11th December 2015

Our Ref: 407.05238.00002
Your Ref: P/DC/JMC/2015/01131/FUL

**RE: PLANNING APPLICATION REFERENCE: 2015/01131/FUL
PROPOSED REMOVAL OF FILL MATERIAL, IMPORTATION OF INERT WASTES
WITH THE PROGRESSIVE RESTORATION OF THE FORMER MINERAL
WORKING AREAS ASSOCIATED WITH THE FORMER ELY BRICKWORKS**

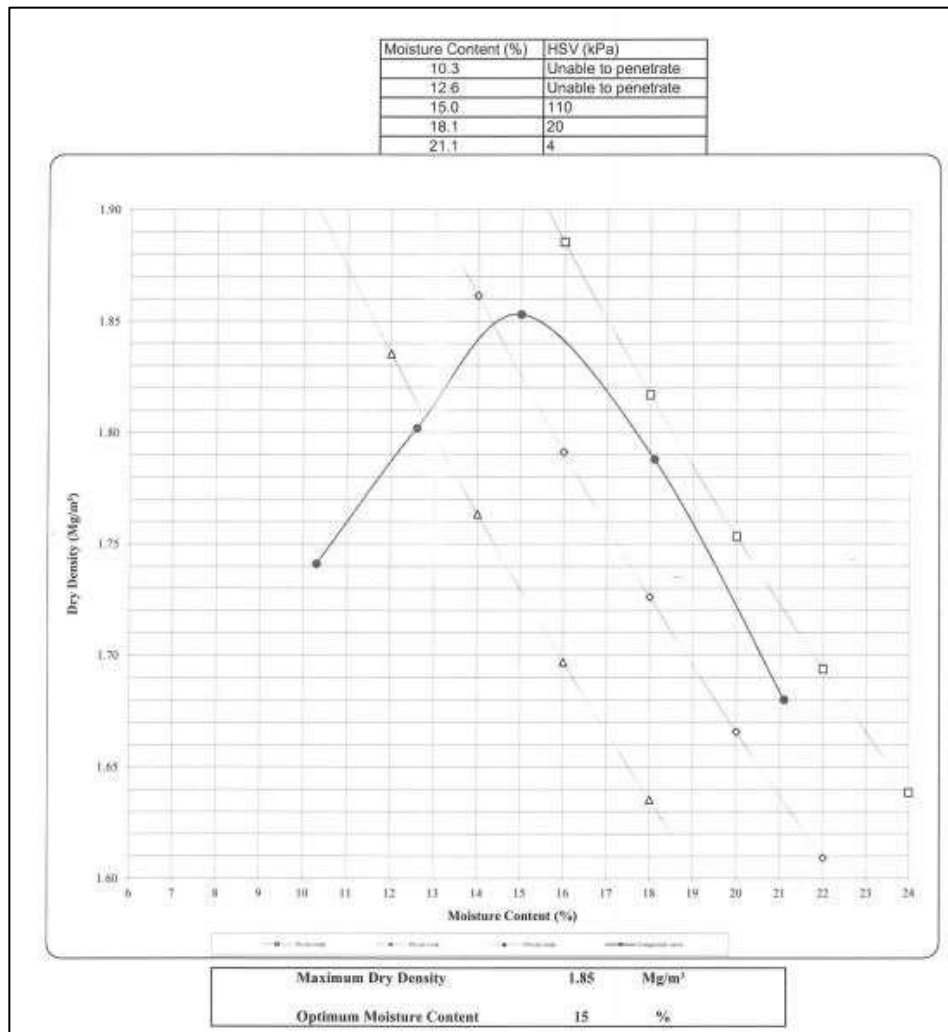
"If this is a genuine restoration scheme rather than a landfill site for the disposal of inert waste, there should be no need to remove material from the site unless there are genuine geo-technical reasons for doing so. No Geo-technical assessment has been submitted demonstrating that any material has to be excavated and is of such a type that it cannot be incorporated into the restoration scheme.

The results show that the material is consistent with regard to the atterberg limits, clay content and low permeability, the soil also has a high silt content. The shear strength was tested at different moisture contents when establishing the optimum moisture content/ dry density curves (see figure above). It was found that the shear strength was very low (<20kPa) where moisture content was greater than 18%; two of the three samples (B1 and B2) had a moisture content greater than 18%. For context a good engineered fill would be expected to have a minimum shear strength of >50kPa.

The low shear strength, which is most likely due to the high silt content, would indicate that this material would not be a suitable platform for backfilling with inert waste due to the potential risk of failure. The investigation recommended that the backfill material should be excavated and the virgin material below the backfill should be exposed to ensure that a firm subgrade is achieved prior to construction of a low permeability geological barrier and subsequent backfilling with inert waste. It is anticipated that selected backfill soils will be suitable for construction of the barrier, particularly those at greater depths which would be expected to have lower moisture content and thus greater shear strength than the soils at the surface. The proposal to remove the historically backfilled material is therefore based on the material stability test results.
